# **IAEA INTERNATIONAL PEER REVIEW MISSION ON MID-AND-LONG-TERM ROADMAP TOWARDS THE DECOMMISSIONING OF TEPCO'S FUKUSHIMA DAIICHI NUCLEAR POWER STATION UNITS 1-4 (Third Mission)**

**Tokyo and Fukushima Prefecture, Japan  
9 – 17 February 2015**

**MISSION REPORT TO  
THE GOVERNMENT OF JAPAN**

FIG. 2. Contaminated water treatment and storage scheme.

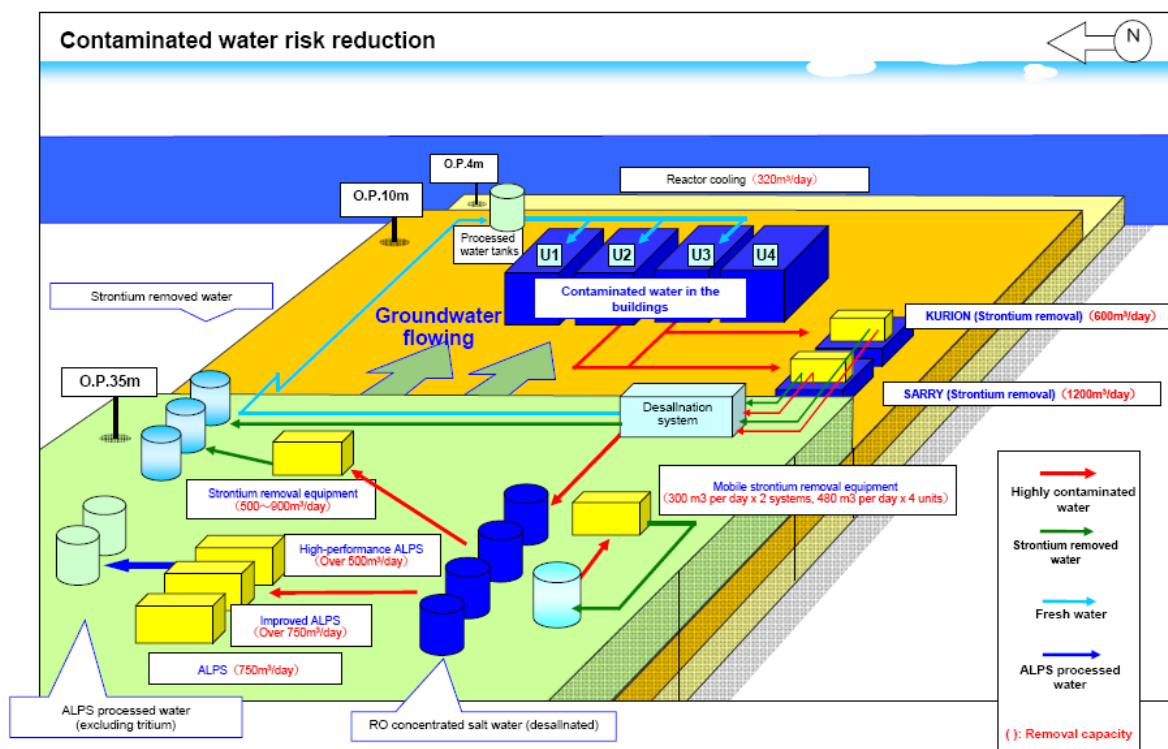
Whilst acknowledging TEPCO's efforts to reduce the risk of storing large volumes of highly radioactive water by removing strontium and other radionuclides as quickly as possible, the IAEA team believes waste minimization should also be an important consideration in such efforts.

Each new piece of equipment adds to the radioactive waste to be managed, and several more items are planned for installation. The IAEA team was informed that this was done because available treatment capacity was not sufficient to meet target deadlines. For example, the actual operating capacity of the three ALPS systems has been only 1200 m<sup>3</sup>/day as compared to their full design capacity of 2000 m<sup>3</sup>/day. Discussions during the mission indicate that this shortfall may be related to the complexity of the treatment flow sheets and the use of newly developed selective sorbents being industrially deployed for the first time. There is, for example, a need for frequent cleaning or replacement of the cross flow filters in the first two ALPS systems, resulting in significant downtime. Lower than expected service life of strontium sorbent in the high performance ALPS system is another example. Obviously, fine-tuning operating conditions and achieving performance targets for these systems is taking more time than initially estimated. TEPCO needs to resolve these issues promptly and optimize the various processes.
